MONTGOMERY COUNTY HISTORIC PRESERVATION COMMISSION
STAFF REPORT

| Address: | 7714 Takoma Ave., Takoma Park | Meeting Date: | 4/25/18 |
| Case Number: | 37/03-18X | Staff: | Dan Bruechert |
| Proposal: | Building Addition | | |

Figure 1: Right side of the house showing the location of the proposed hallway.

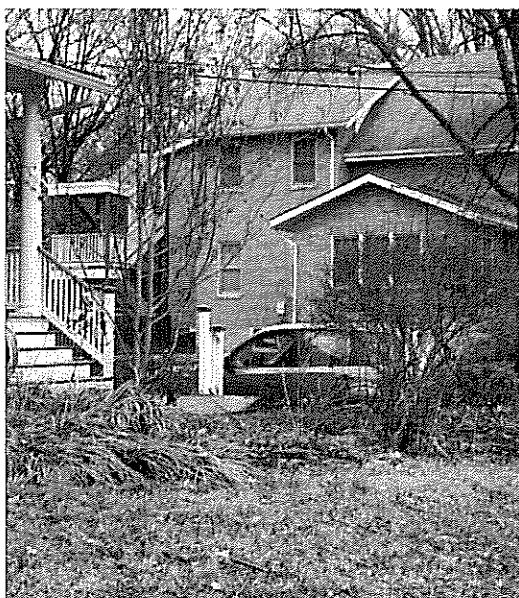
The applicant is proposing to construct a rear gable addition off of the left rear corner of the house that will be accessed by a newly created hallway. The addition will be approximately 17' × 21' (seventeen feet by twenty-one feet) and will have a brick foundation and be clad using Hardi siding with a 10" (ten inch) reveal with a steeply-pitched metal roof. The addition in the rear will project 4'2" (four feet, two inches) beyond the wall plane of the historic side gable-L at the front of the house. The creation of the new hallway will require the removal of the historic exterior wall behind the side gable-L addition (see Fig. 1 below).

Staff finds that the applicant made several revisions based on the recommendations by the HPC at the February 13th meeting. The location of the addition has been moved further toward the rear, and it projects much less than the previous submission (see attached) that projected more than 14' (fourteen feet) from the side gable-L. The roof form has been simplified, so that the new hallway is covered in a shed roof, with a single rear-facing gable roof over the addition, instead of the more complex side and rear gable proposal previously submitted. One substantial change from the previous submission has to do with the height of the roof on the addition. The proposed roof is much taller than the previous submission. The ridgeline extends to the eave of the rear gable on the historic house (at the level of the attic floor). This is 6' - 8' (six feet to eight feet) taller than the side gable-L roof at the front of house and will be largely visible from the public right-of-way.

The HPC voiced support for moving any building additions to the rear of the house, determining that the side and rear elevations (visible from Philadelphia Ave.) are secondary elevations and can accommodate more change without damaging the historic character of the building. The applicant has relocated the proposed construction, however, it still projects beyond the wall plan.
